RECEIPT DATE: 11/16/22 **ONSITE SEWAGE DISPOSAL SYSTEM**

APPROVAL DATE: **PERMIT: CONSTRUCTION**

PROPERTY ADDRESS: 1442 HERITAGE RIDGE ROAD, WOODBINE, MD 21797

SUBDIVISION: LINDEN GROVE, PHASE 2 LOT: 35 TAX ID: 04-603257

Shapiro  
 Notes for  
 Linder Core lot  
 35

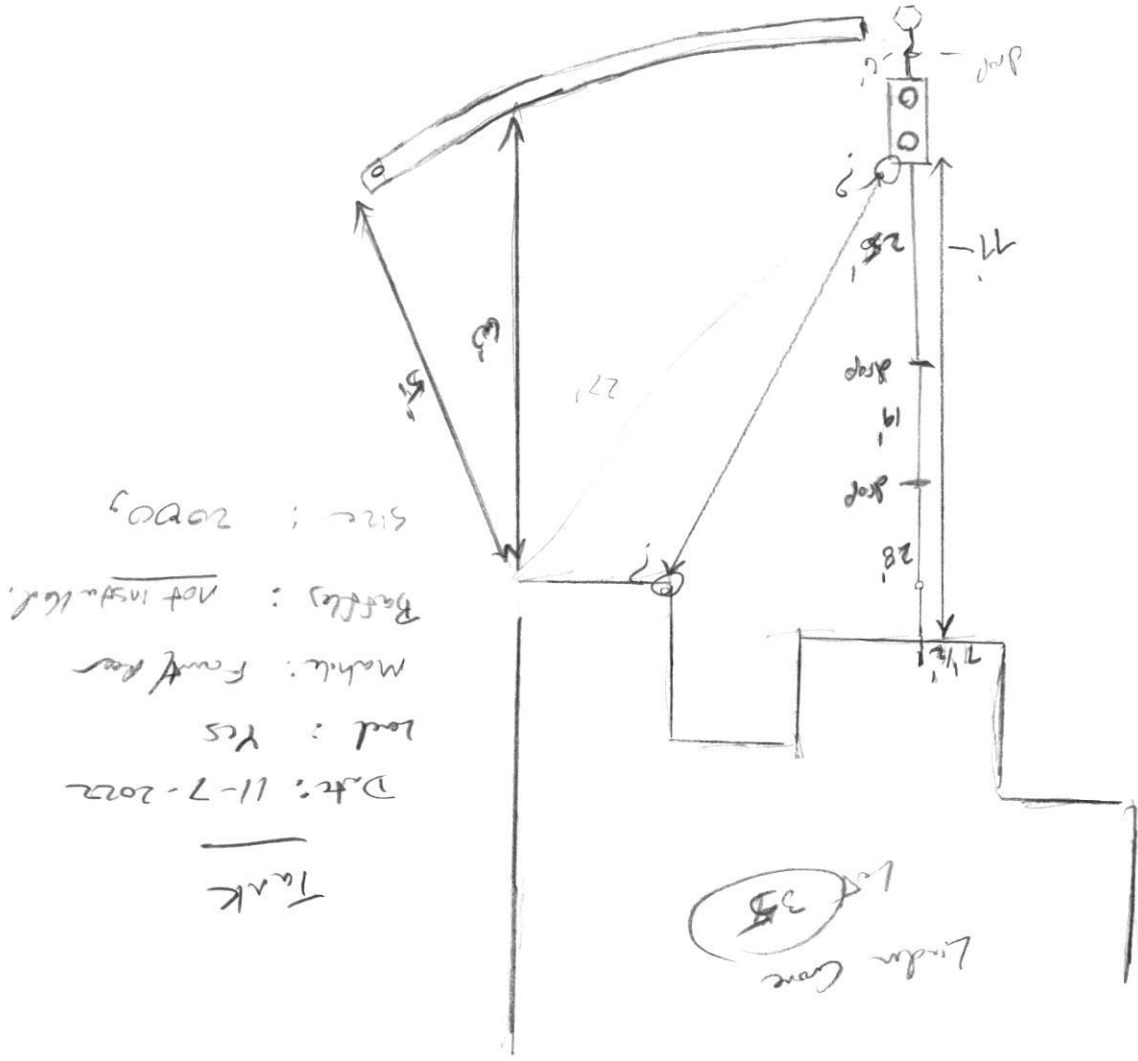
11/30/22 On site for inspection. T<sub>1</sub> & T<sub>2</sub> moved slightly to meet contour. Both trenches 71.5'. Tank & SDA staked. Could not verify septic out of house. OK to start building. *(initials)*

12/2/22 Tank set. D box set per plan. Still more plumbing installed w/ drops to D box. upper trench being installed stayed onsite until trench was complete.

OK to cover work & continue. Need to inspect lower trench & level D box. *(initials)*

12/5/22 trench, 2 hrs inspected. Rock & fabric was good. inlet is at 3' instead of 3.5'. observation port in place. During inspection of tank, slot was filled w/ concrete, needs to be reinspected.

12/16/22 - verified slots in tank *(initials)*
